# **Industry Response to Flowserve Part 21 on Anchor Darling Double Disk Gate Valves and NRC Staff Next Steps**

Public Meeting  
February 15, 2018

# **NRC Observations on BWROG Guidance**

# LaSalle Unit 2 As Left Thrust/Torque Trace After Rework

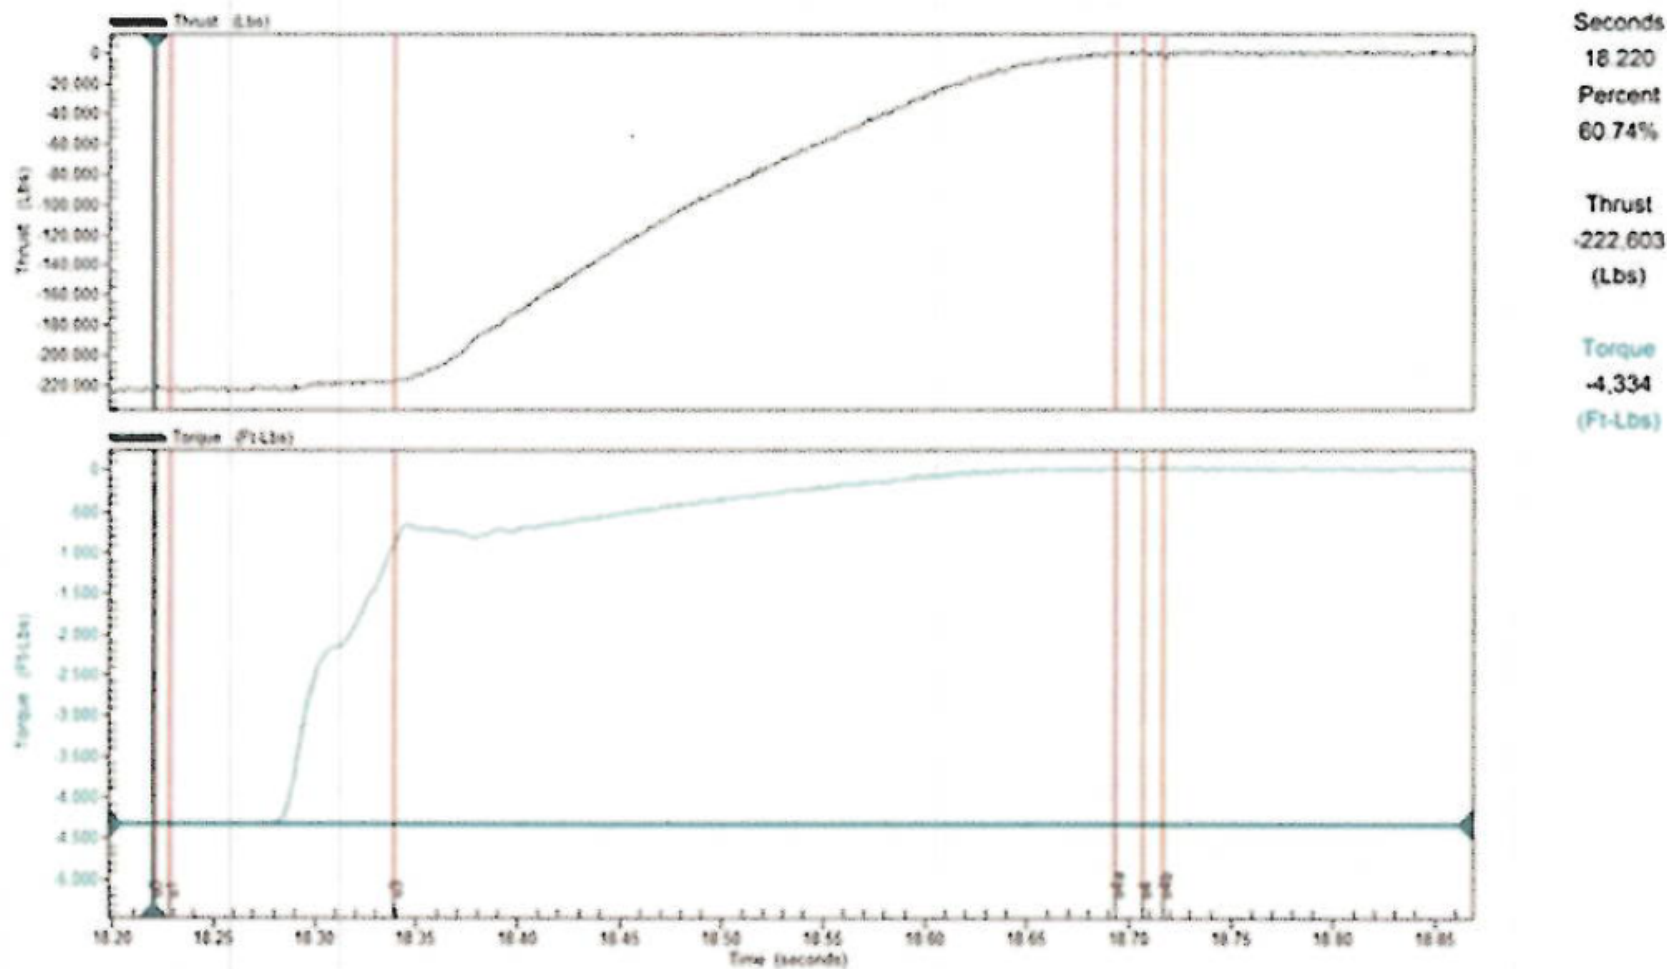
# **Example of Diagnostic Test Inability to Conclusively Determine Degradation of Stem-to-Wedge Connection**

## LaSalle Unit 2 Anomaly 2015 - Example used in BWROG Guide as Active Stem-to- Wedge Connection Degradation
